Access Compliance Report

Public Rights-of-Way

(Curb Ramps)

Intersection ID: 9796	Main Street: BARRINGTON_DR	Cross Street: MONTEGO_DR	Location: SW
ADA ID: 9EA6496018DA	Ramp Type: Perp	Initial Pass/Fail: Fail	Overall Compliance: No
Severity Score: 33.75			
Codes/Mitigation Info/Possible Solution		Field Measurements/Component Compliance

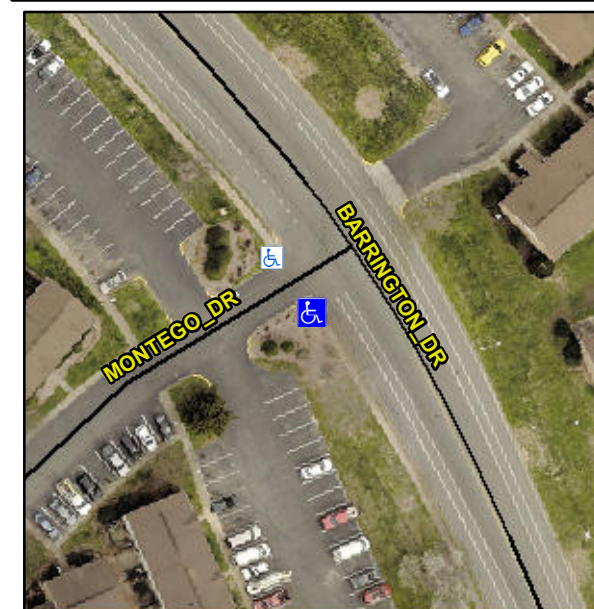
Not Found, R304.5.1, R304.5.3

Compliance	Description	Data	Compliance	Description	Data
N/A	Ramp Length (in)	27.0	Yes	Ramp Slope (%)	6.1
No	Ramp Width (in)	47.5	No	Ramp XSlope (%)	7.3
N/A	Flare Type LT	N/A	N/A	Flare Type RT	N/A
N/A	Flare Slope LT (%)	N/A	N/A	Flare Slope RT (%)	N/A
N/A	Flare Traversable LT?	N/A	N/A	Flare Traversable RT?	N/A
N/A	Landing Length (in)	N/A	N/A	DWS Provided?	N/A
N/A	Landing Width (in)	N/A	N/A	DWS Contrast?	N/A
N/A	Landing Slope (%)	N/A	N/A	DWS Length (in)	N/A
N/A	Landing X Slope (%)	N/A	N/A	DWS Full Width?	N/A
N/A	Landing Curb? (Y/N)	N/A	N/A	DWS Offset (in)	N/A
N/A	Shared Landing?	N/A			
N/A	Gutter Ponding?	N/A	N/A	Gutter Slope (%)	N/A
N/A	Gutter Lip Ht (in)	0.75	N/A	Gutter X Slope (%)	N/A
N/A	Painted X Walk1?	No	N/A	Painted X Walk2?	N/A
	X Walk 1 Direction	To NW		X Walk 2 Direction	N/A
N/A	X Walk 1 Width (in)	N/A	N/A	X Walk 2 Width (in)	N/A
	X Walk 1 Slope (%)	4.5		X Walk 2 Slope (%)	N/A
	X Walk 1 X Slope (%)	6.9		X Walk 2 X Slope (%)	N/A

Remove & Replace Entire Ramp.
